La Vergne Planning Commission
September 24, 2024 at 5:30 PM

Planning Commission Report Meeting: September 24, 2024	City of La Vergne

SHEET C-4.01
REV.

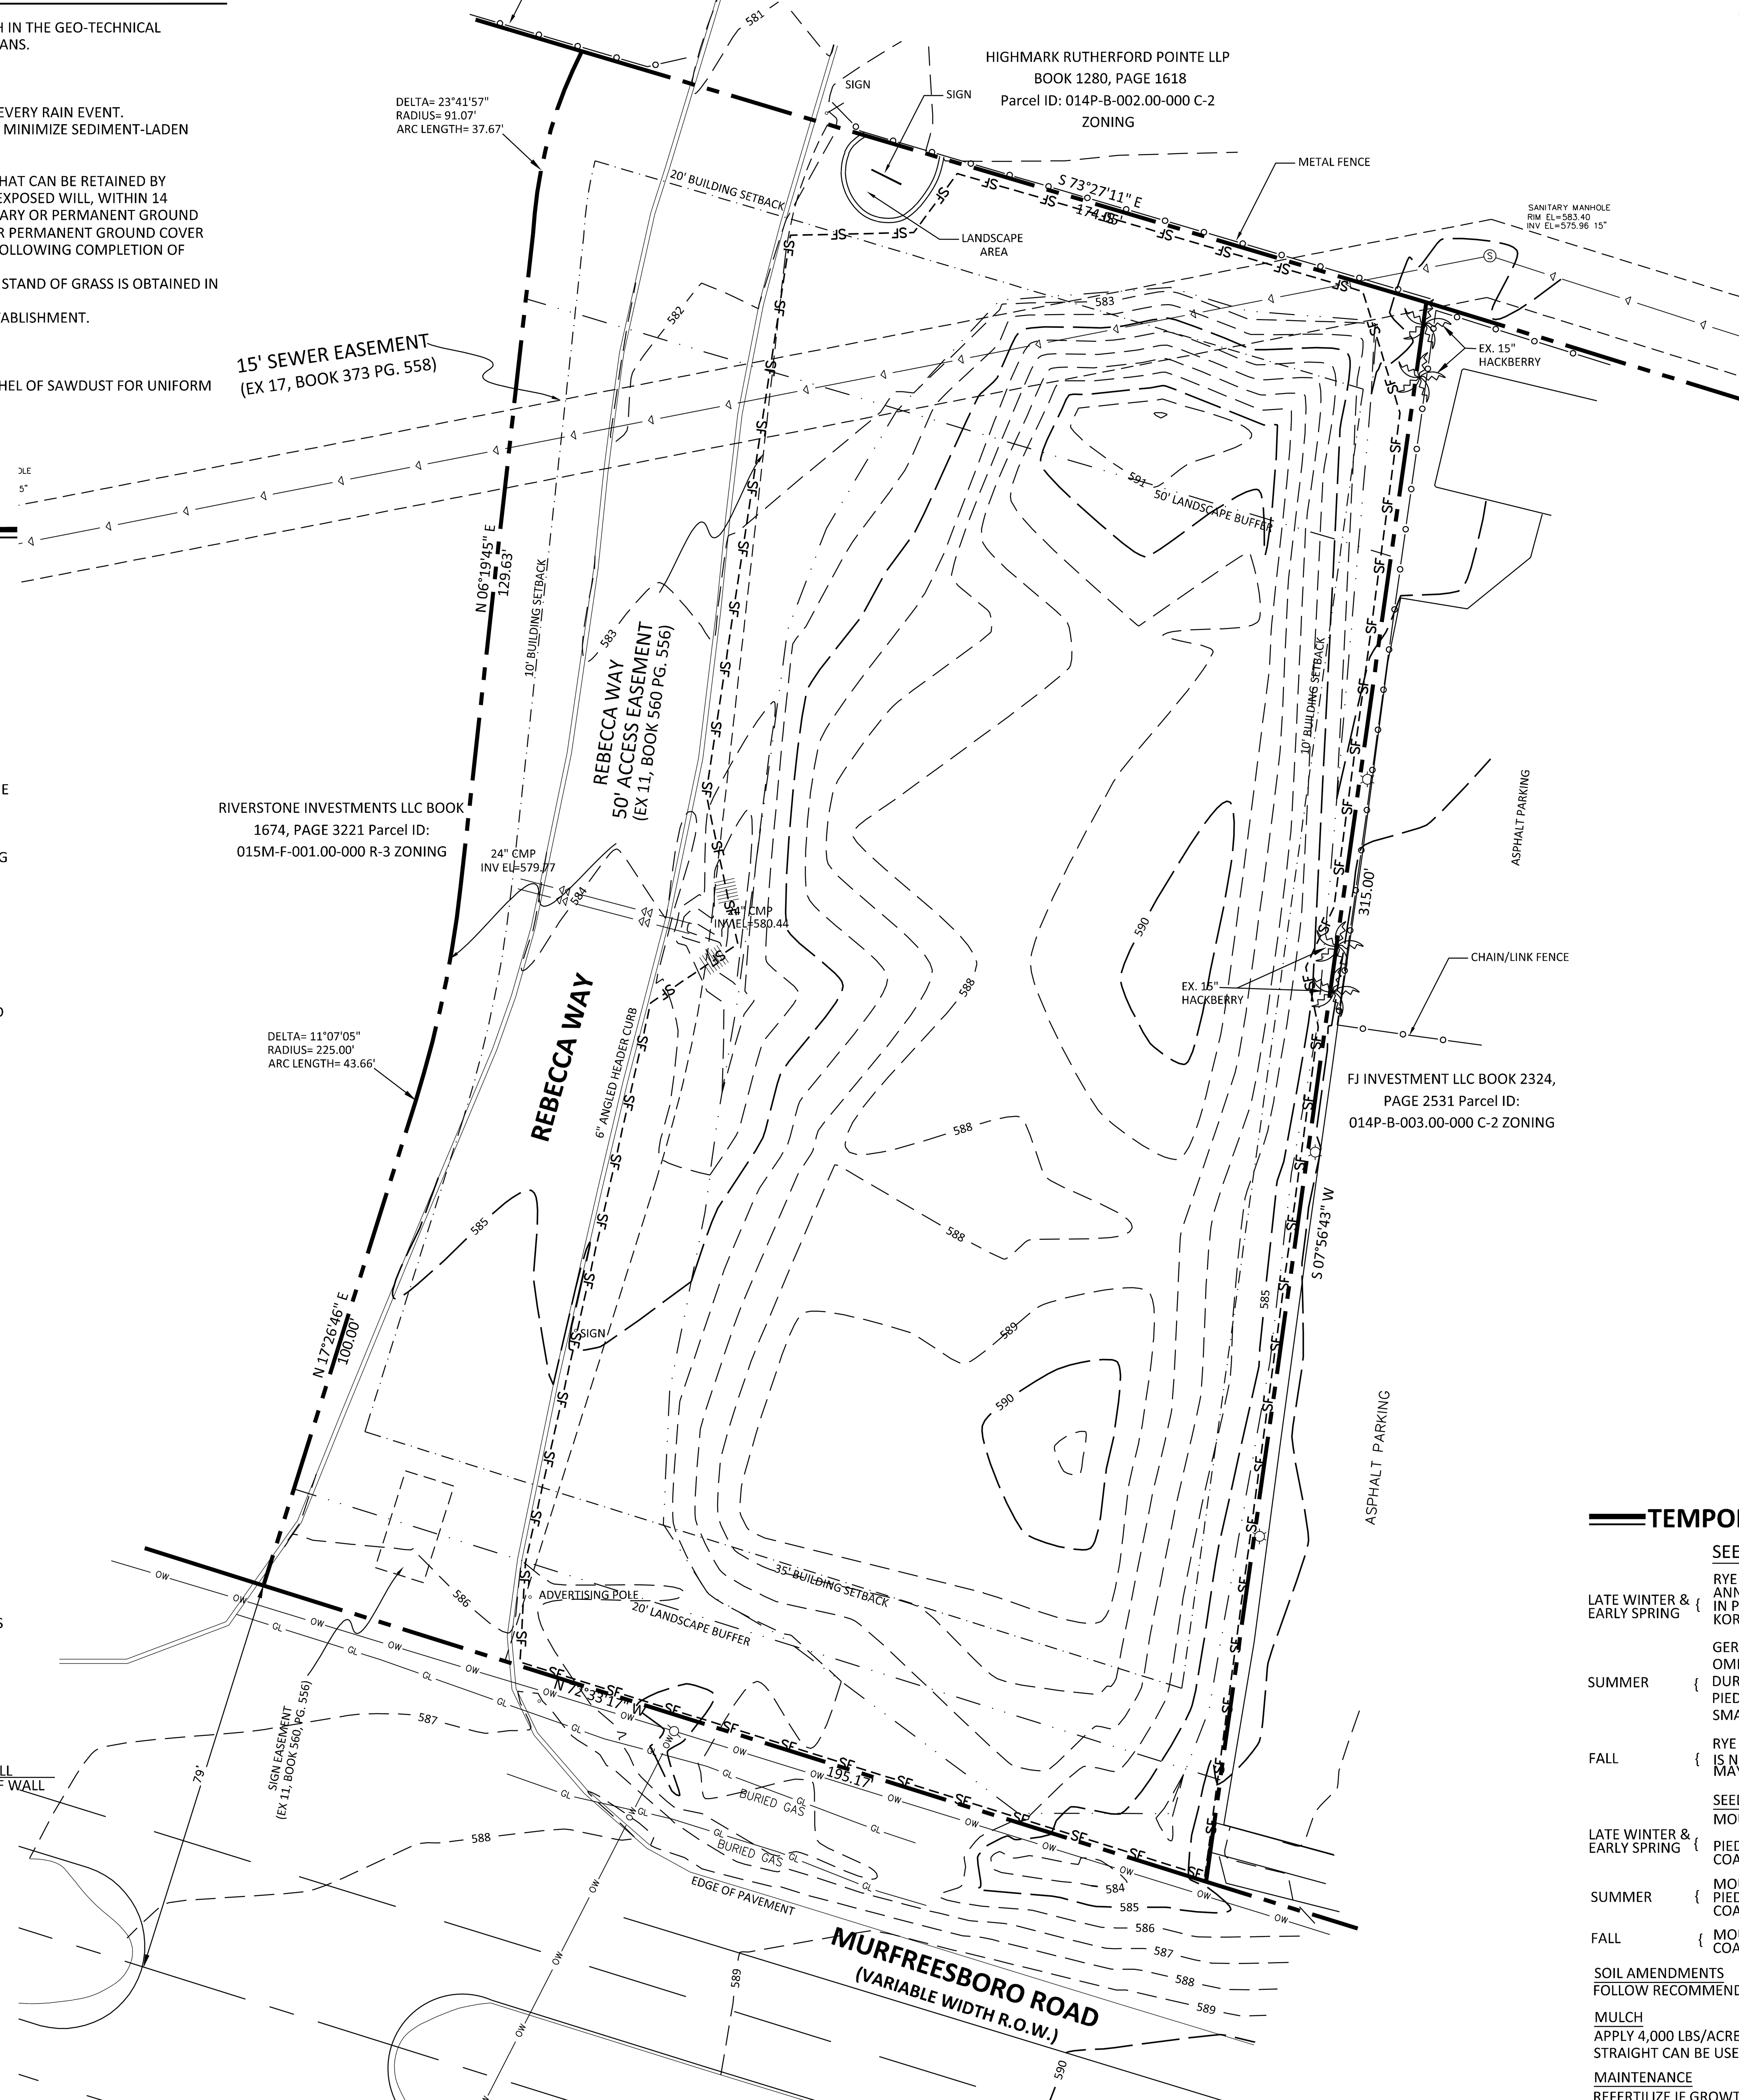
5. (Sheet C-4.01) Provide the following:
    a. Location of Permit Board
    b. Location of concrete wash-out
    c. Show construction entrance on this plan as it will be required for the initial EPSC inspection sign-off

d. Label temporary construction entrance as a minimum of 100 feet long and 20 feet wide.
6. (Sheet C-9.02) Provide architectural details (height, width, illumination, etc.) for monument sign designated at 'Q'.

SHEET
C-5.01
REV.

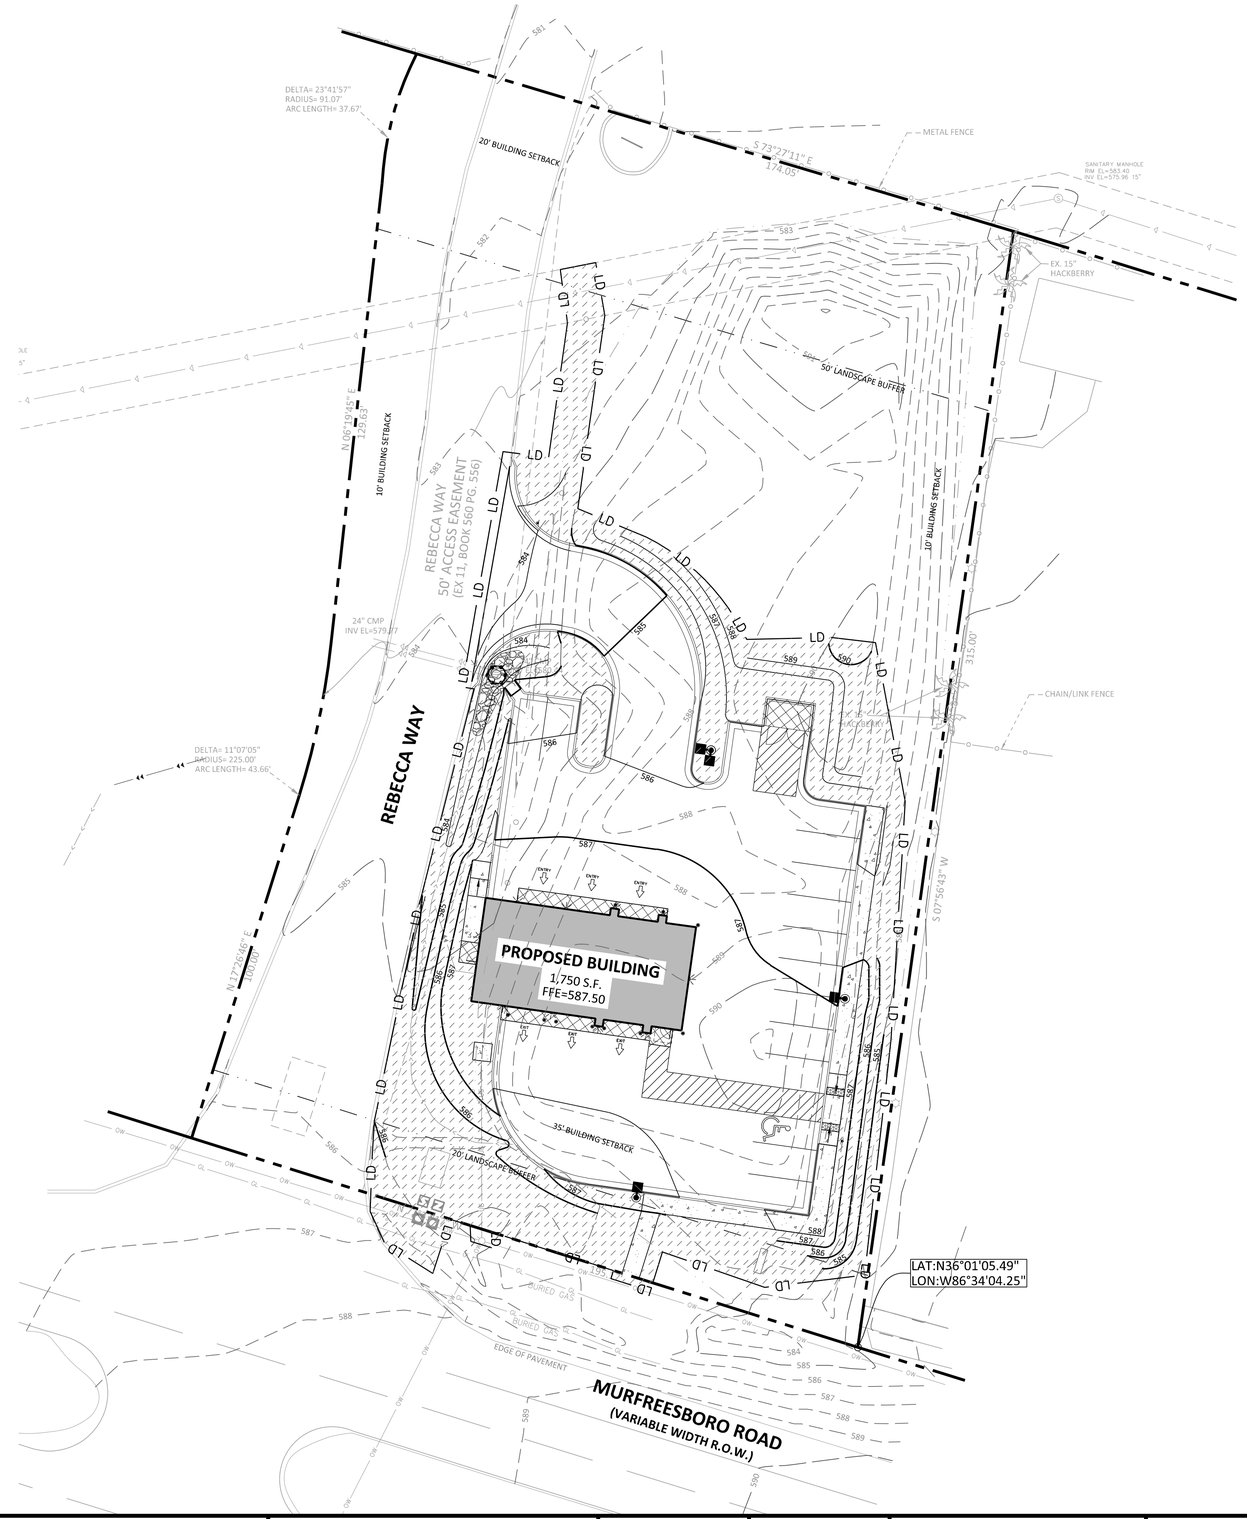
9. (Sheet C-5.01) Show permanent groundcover/stabilization for areas of site which are outside the limits of disturbance and the landscape buffer area.
10. (Sheet C-5.01) Show area of buffer landscaping within the Limits of Disturbance
11. (Sheet C-1.01) Add the buffer landscaping area to the Disturbed Area calculation in the Development Summary on Sheet C-1.01. .
12. (Sheet C-6.01) You will get more information on this from the Utilities Engineer but there is a 12-inch waterline just off the northern boundary of this property. Accessing it would require getting a small easement from Rutherford Pointe Apartments but would probably be easier than boring under Murfreesboro Road. (See Plat Book 24, Page 172 for location)
13. Add a note stating the flood zone of the site based on the May 2023 FIRM mapping.

SHEET
C-6.01
REV.

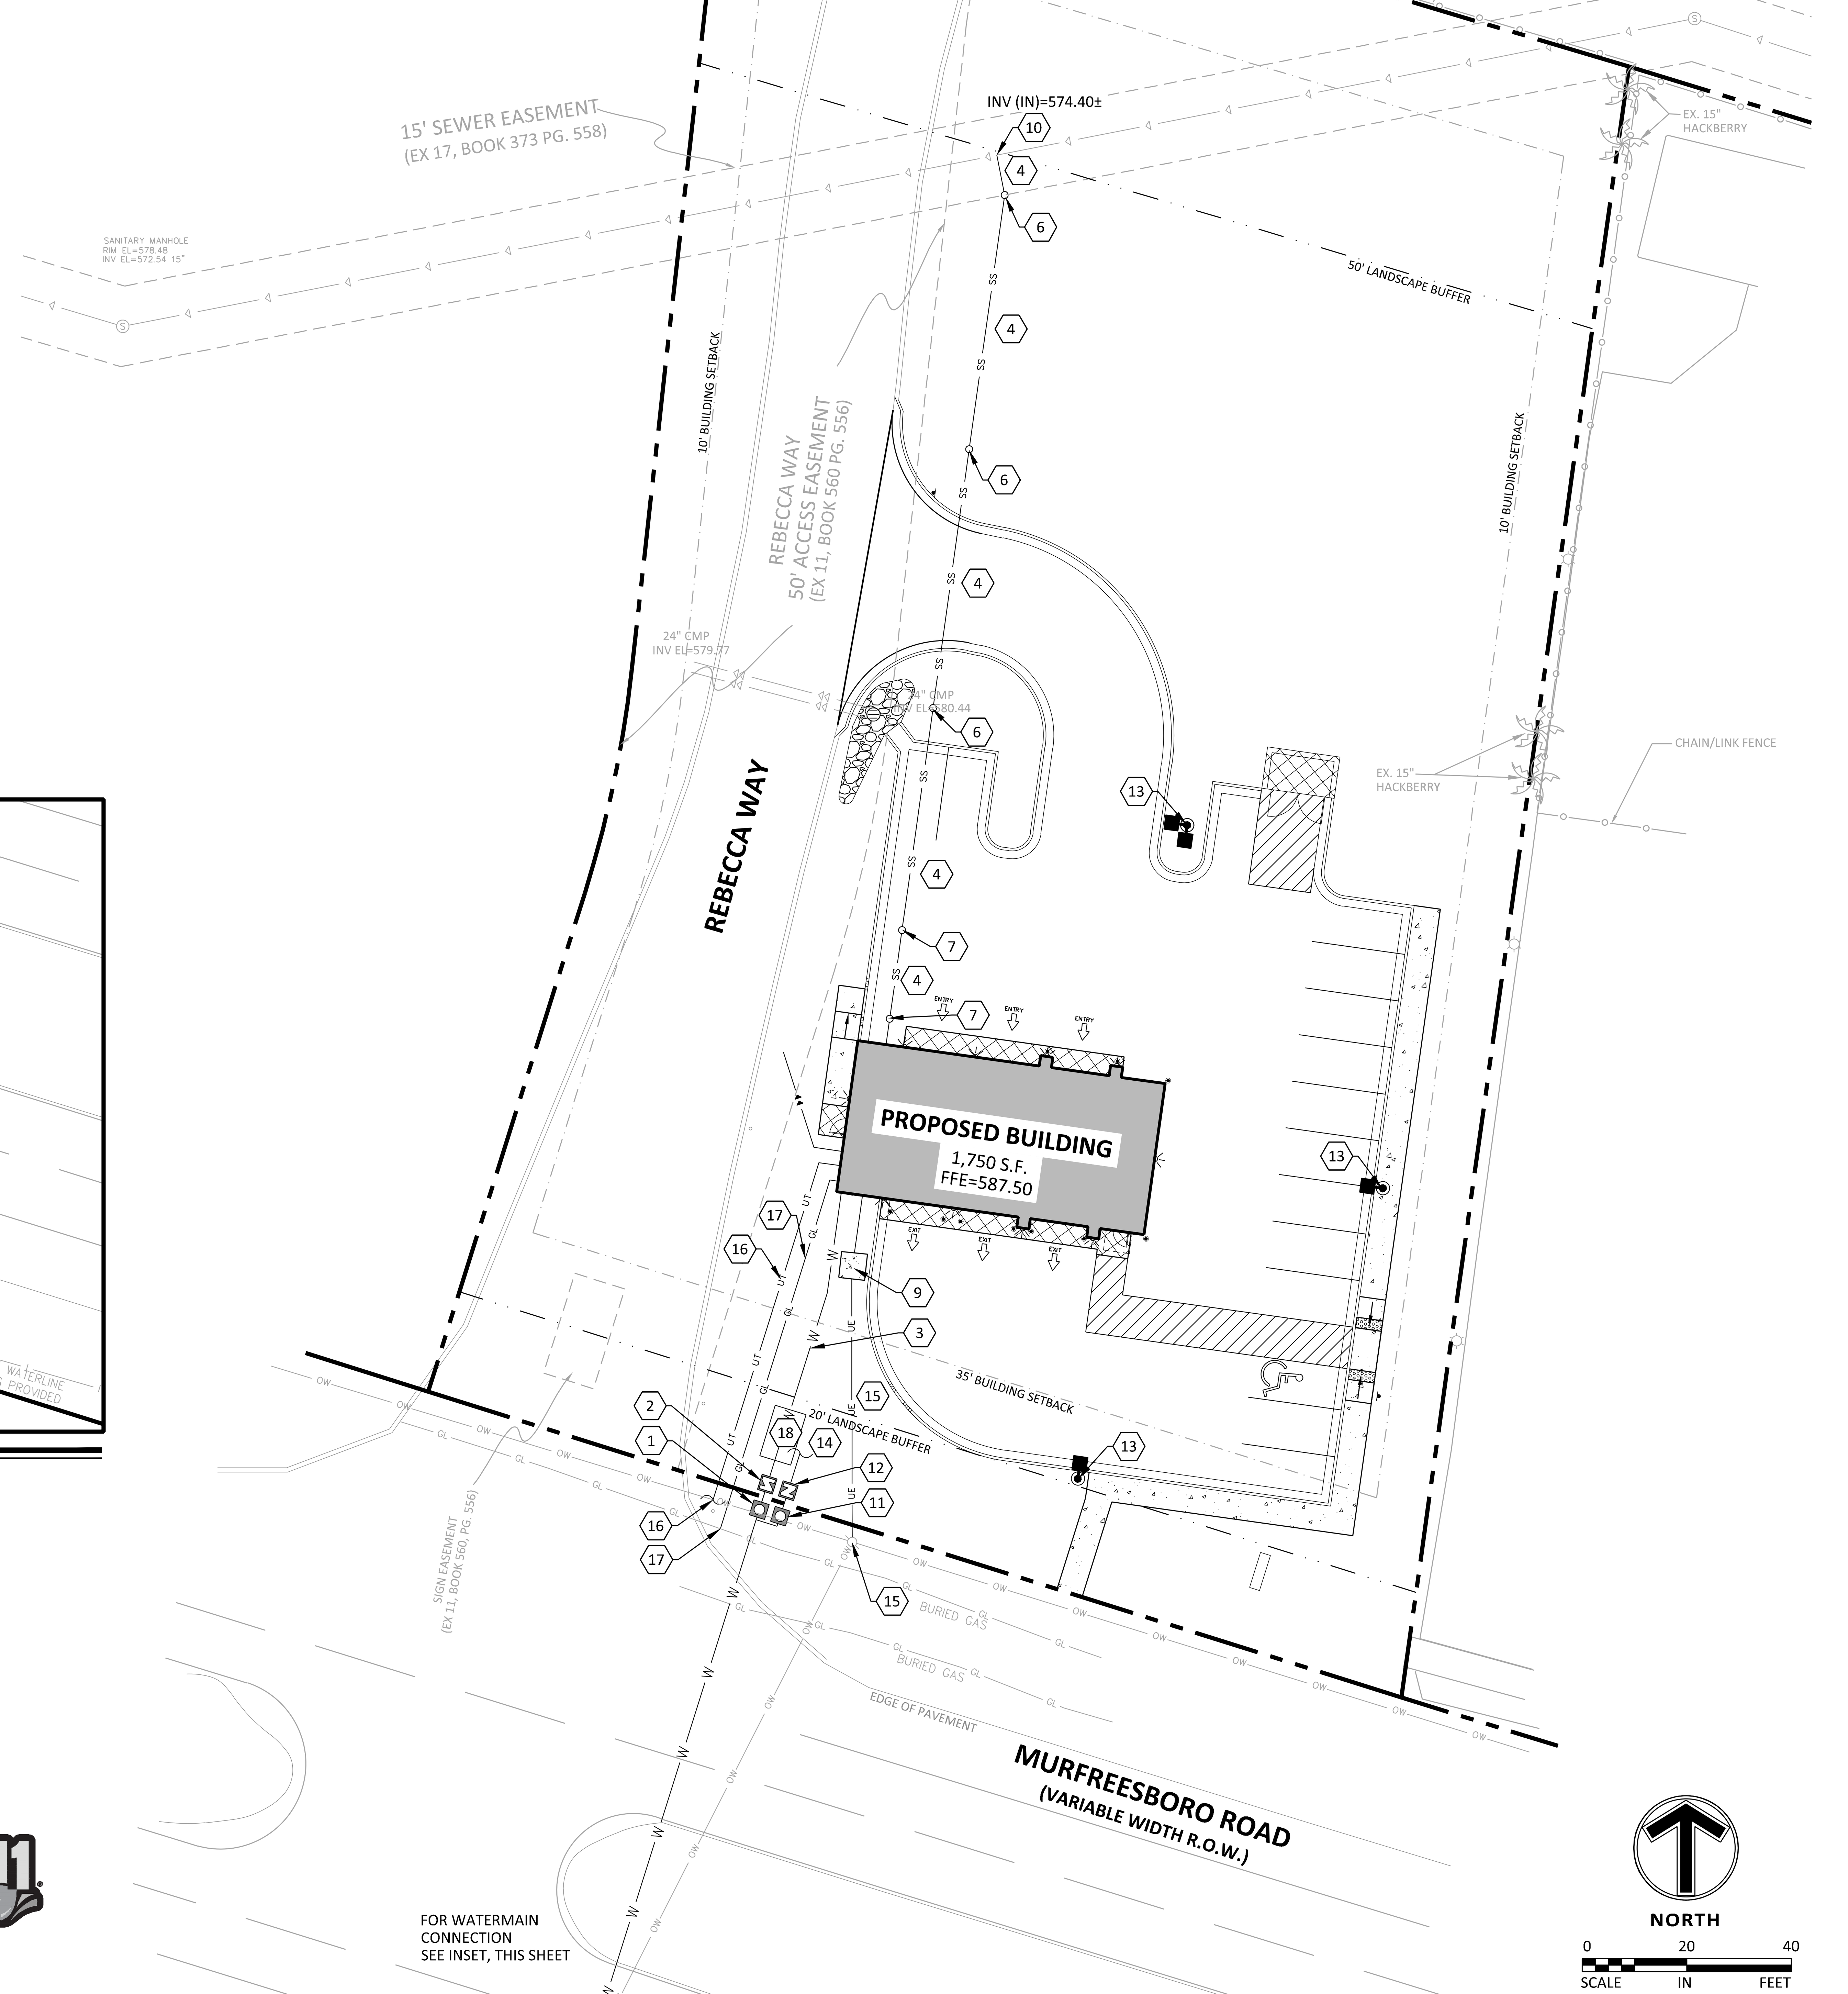
7. (Sheet C-9.02) Provide architectural details (height, materials, etc.) for trash enclosure designated at 'V'.
8. (Sheet C-6.01) Please show city standard utility details. They can be found at the following locations:
